PRODUCT CORRECTION

Air10™ Series Humidifier Software Upgrade

Normal operation; error message displayed; device showing humidifier off

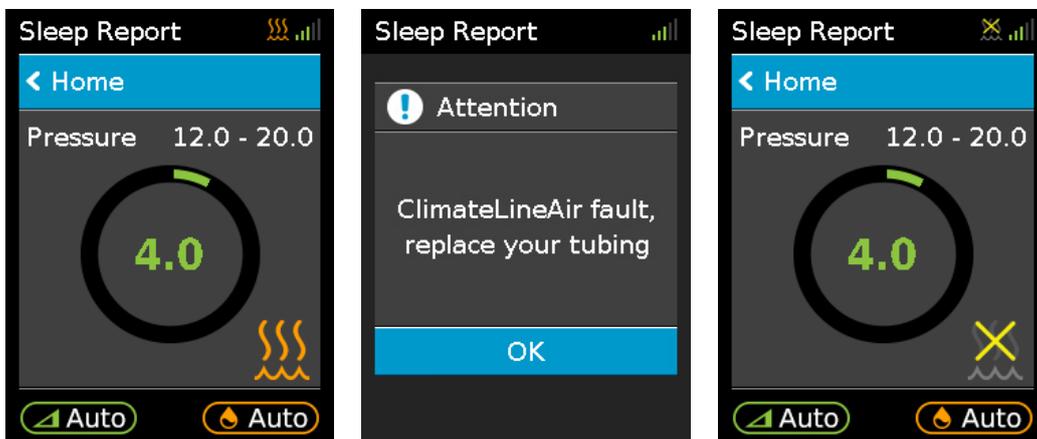
A number of Air10 devices have shown a ClimateLineAir™ error message on the user interface. This is primarily caused by the software interpreting static electricity as a fault with the tubing. Static can be common in cold and dry environments. When this condition occurs, the software generates the message and turns the humidifier off. This is indicated by a yellow “X” through the humidification symbol on the screen as shown below.

Air10 devices affected by this issue are safe to use and there is no disruption to positive air pressure therapy. Today, the message is cleared by pressing OK. Humidification can be resumed by power cycling the device, or by disconnecting and reconnecting the ClimateLineAir tube. With the software upgrade, static electricity will no longer be incorrectly interpreted as a ClimateLineAir fault.
